## Block 2 Requests

Massport Community Advisory Committee (MCAC)

Aviation Subcommittee Meeting April 18, 2018

## Don't be fooled by the MIT density plots

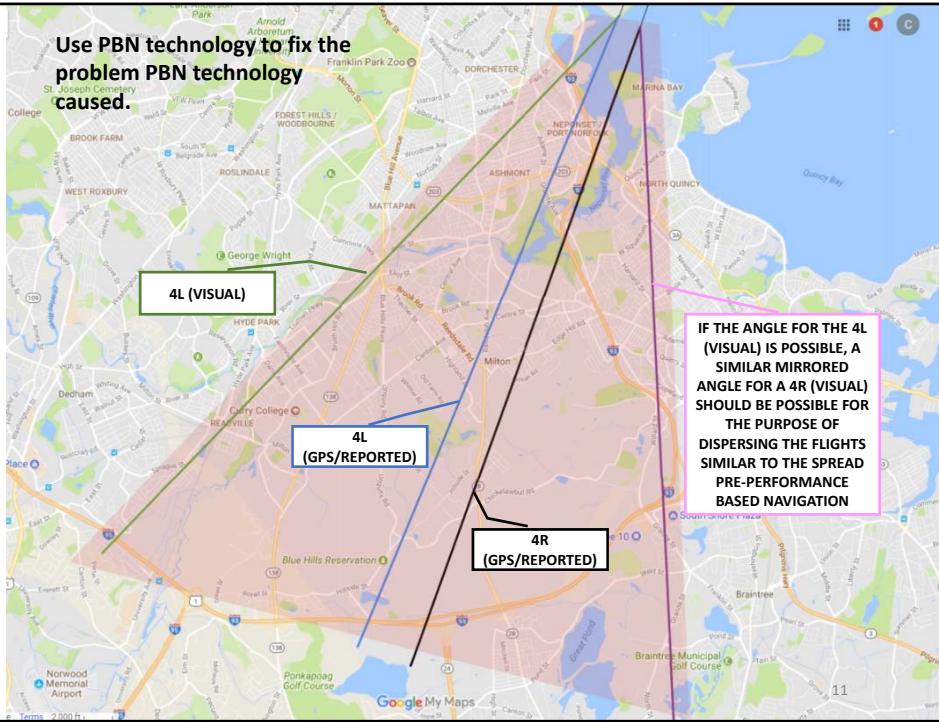
- “Red” = 9 or more fly overs/day, on average, in a year
  - 9/day is 3,300 /year
  - 139/day, like in parts of Milton, is 50,700/year
  - 3,300/year is tolerable; 50,700/year is not tolerable
- The “zoom” is so high that it masks the concentration of flights at 2000 feet and lower, like they are over Milton and Dorchester
  - Departures are higher sooner and this is less of a problem in their density plots
- Other serious, obvious mistakes put into question the quality of the work
  - For example, no information on how high a plane has to be to be counted

- **ALL WORK DONE WITH 4R APPROACHES MUST INCLUDE 4L PROCEDURES TOO**
- **Please do a better job on the density plots for approaches and provide a more appropriate version.**
  - Use a zoom level that is appropriate for the altitude of the procedure
  - When dividing the area into 1-square acre blocks, the blocks need to align with the angle of the flight path, otherwise the graphic could show more dispersion than is actually there.
  - It is inappropriate to use the categorization of 9+ as the highest grouping when some areas have fly overs in the 100+, making the graphs misleading. Please re-do.
  - When counting, one must define what counts – please do that on the requested re-done density plots

## Increase Approach Altitudes – Justifications for Request

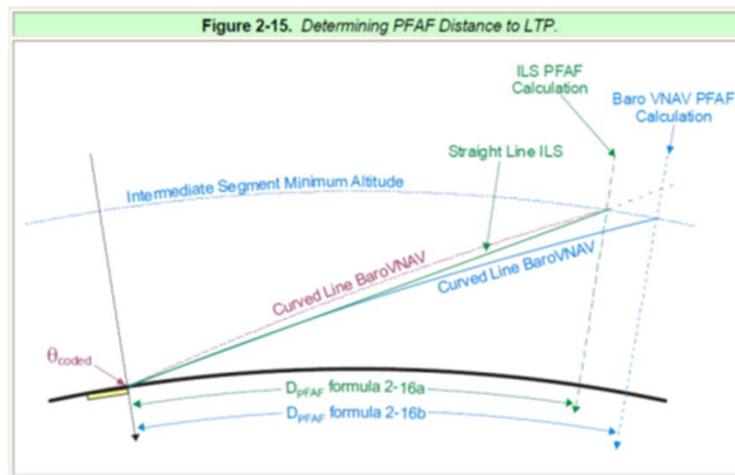
- Several changes from 2009 4R Procedure Chart compared to current Chart
  - Sidestep to 4L
  - **Final Approach Fix altitude was 1800 ft for the instrument approach and now is 1700**
- Radar based-navigation altitudes were higher
  - A change to 4r approached procedure produced, August 2011, effective 12/15/2011, same day as WAAS
    - notes a change to the FAF (MILTT) based on new use of formula 2-16b.
- Increased altitude helps all communities under approach paths, even those under the potential new dispersed RNAV family paths

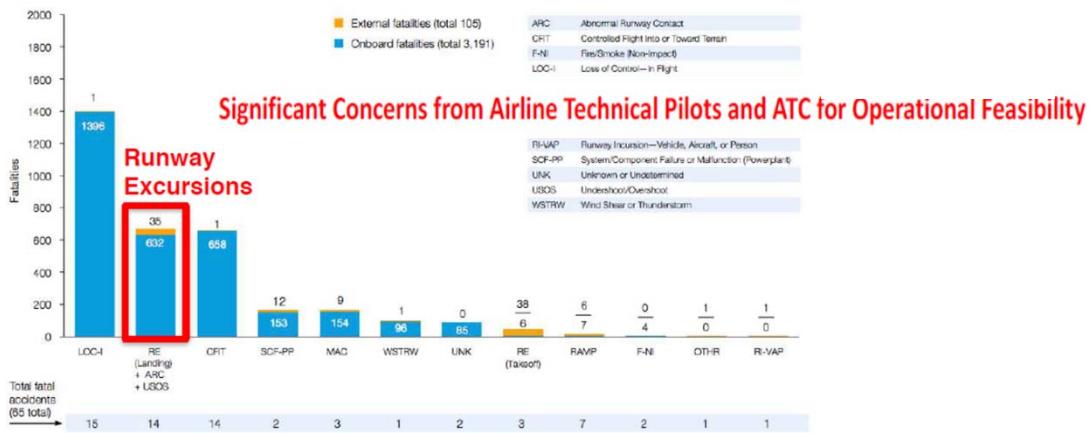
- Consultant simulated noise impact improvements from two types of steeper approaches
- Reported that higher altitudes and steeper approaches are a safety concern because of “landing excursions”
  - Landing excursions are accidents where aircraft veer off or overrun the runway due to difficulties with speed management
- Cited 14 fatal accidents over a 10-year period between 2006 and 2015 that were classified as landing excursions.
- **No other work was reported.**

- Upon my review there is no documentation indicating that these 14 accidents were caused by a steep approach.
  - None of the 14 accidents occurred in the United States. One accident occurred in each of these locations: Russia, Norway, Indonesia, Angola, Brazil, Thailand, Honduras, Sudan, Netherlands, Japan, India, Columbia, Ghana, and the Republic of Congo
  - The last 2 accidents, in Ghana in 2012 and in the Republic of Congo in 2015, involved 30-year old cargo aircraft.
  - Four of the fourteen were associated with wet runways and weather.
- No relevant data or reference given to indicate that a steep approach is associated with runway excursions.

## Runway 4R Arrivals:

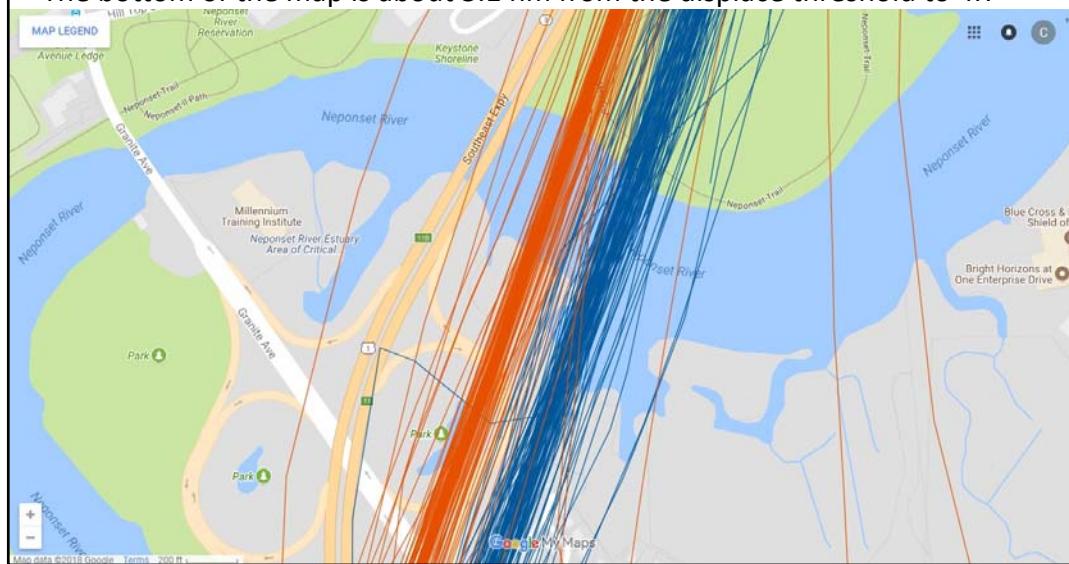
### Two Whys?

1. Why the shift?
2. Why insist that approaches have had no change when the concentration is evident when one uses an appropriate zoom level for the altitude of the planes?
